Re: **Docket No. 521 – Application of Tarpon Towers III, LLC and Cellco Partnership d/b/a Verizon Wireless for a Certificate of Environmental Compatibility and Public Need for the Construction, Maintenance and Operation of a Wireless Telecommunications Facility at 1021-1041 South Main Street in Cheshire, Connecticut**

RESPONSES OF CELLCO PARTNERSHIP D/B/A VERIZON WIRELESS TO
CONNECTICUT SITING COUNCIL INTERROGATORIES (SET ONE)

Existing Verizon Wireless 5G Coverage
Cheshire, Connecticut and Surrounding Area
 (*Map Scale is 1:16,000)

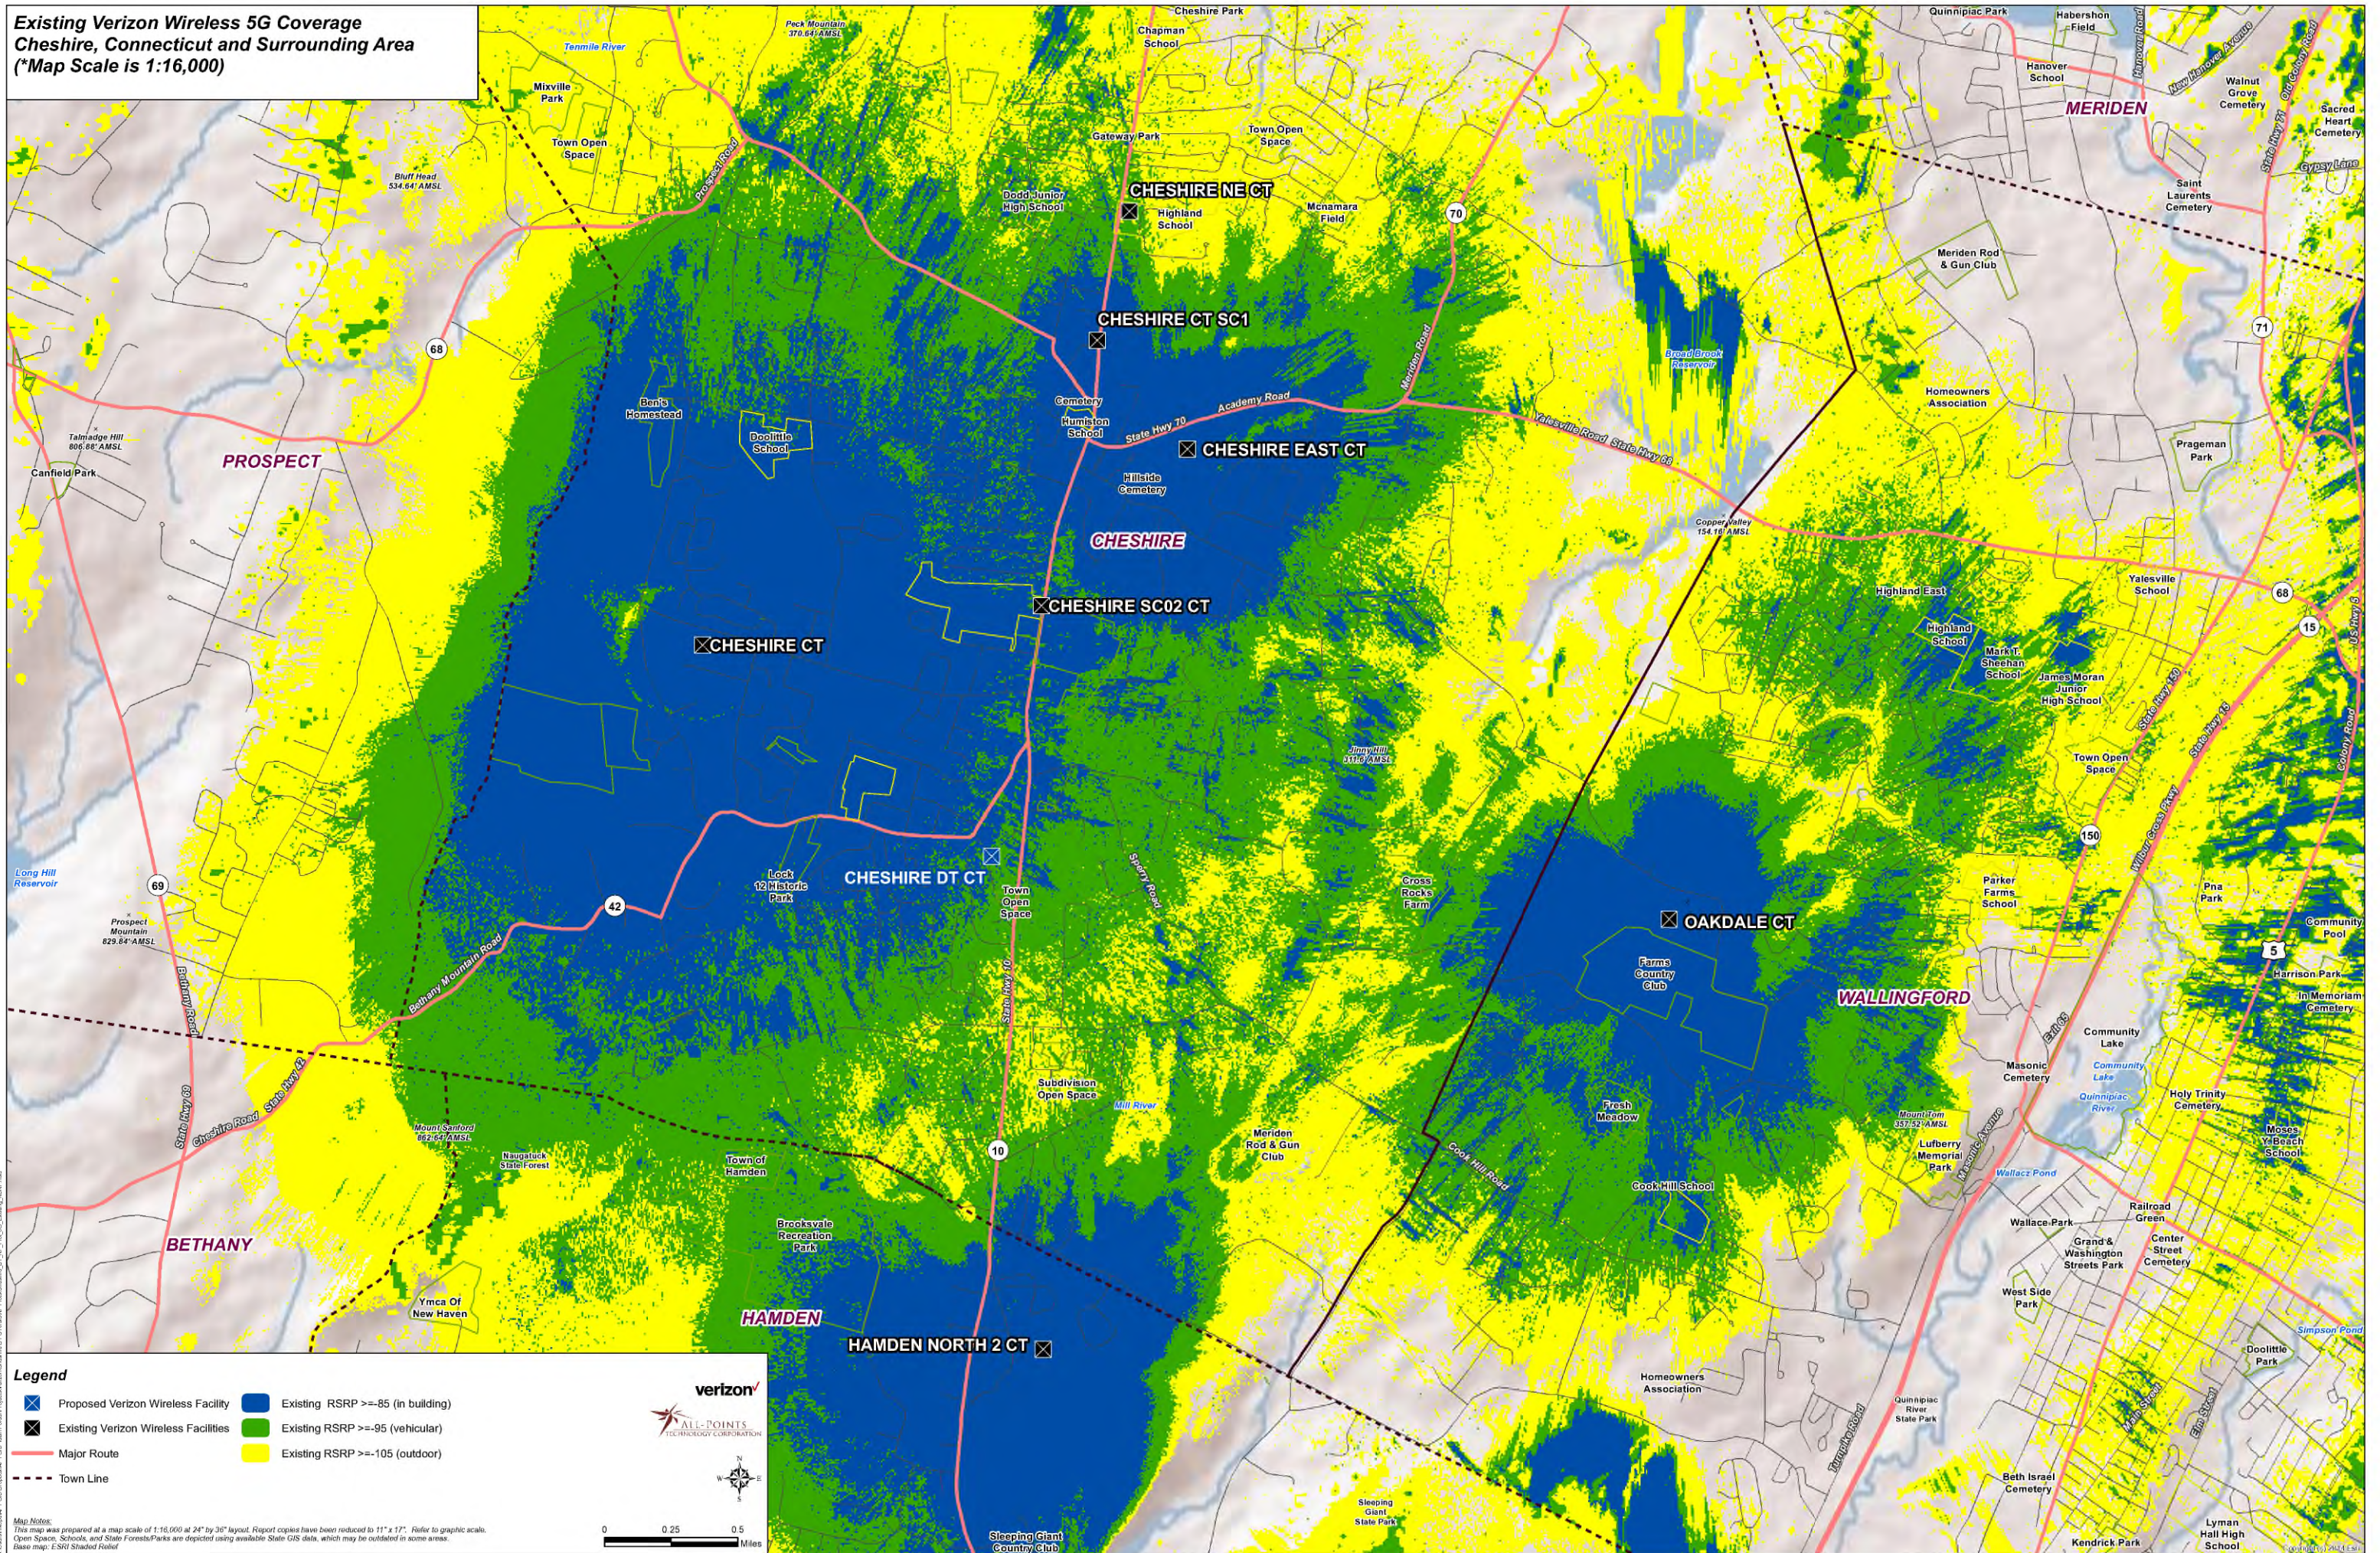
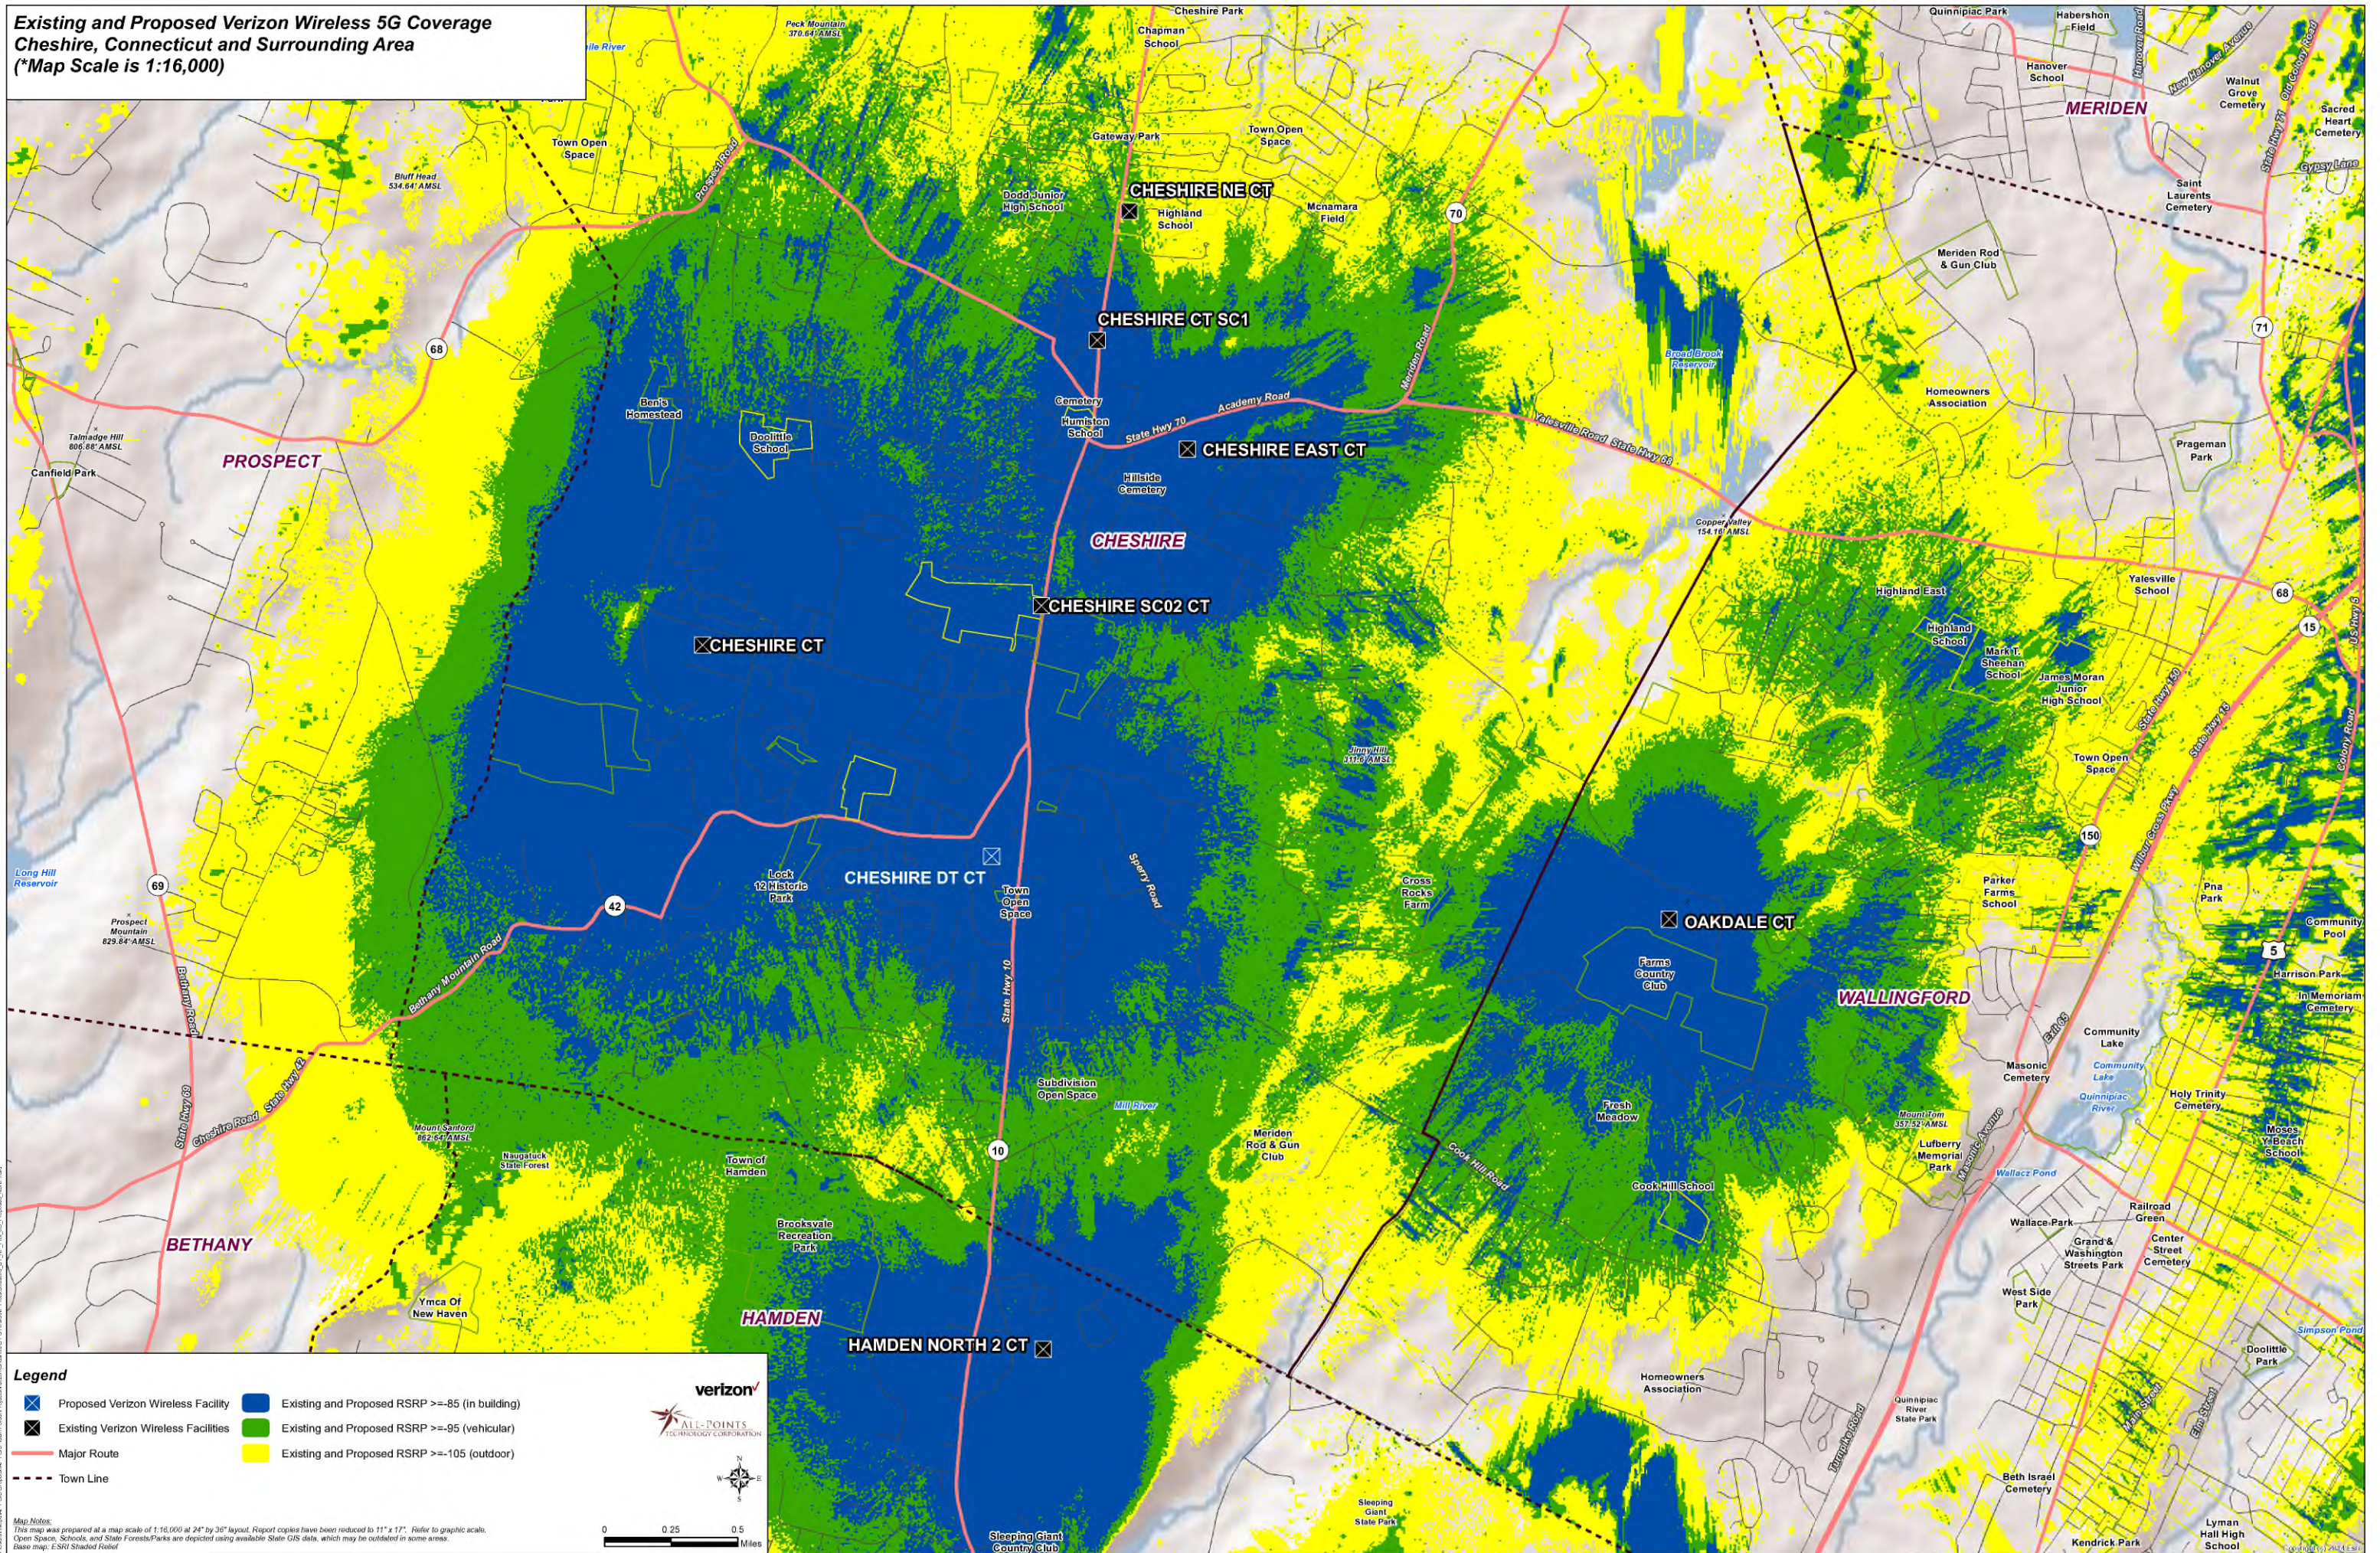
Are all frequencies used to transmit voice and data?

All of Cellco’s licensed frequencies (700 MHz, 850 MHz, 1900 MHz, 2100 MHz, 3550 MHz, 5G) are used, however, to transmit both voice and data services. Included in Attachment 1 are “Existing” and “Existing and Proposed” coverage plots for Cellco’s 3500 MHz and 5G frequencies, which were not included in the Application.
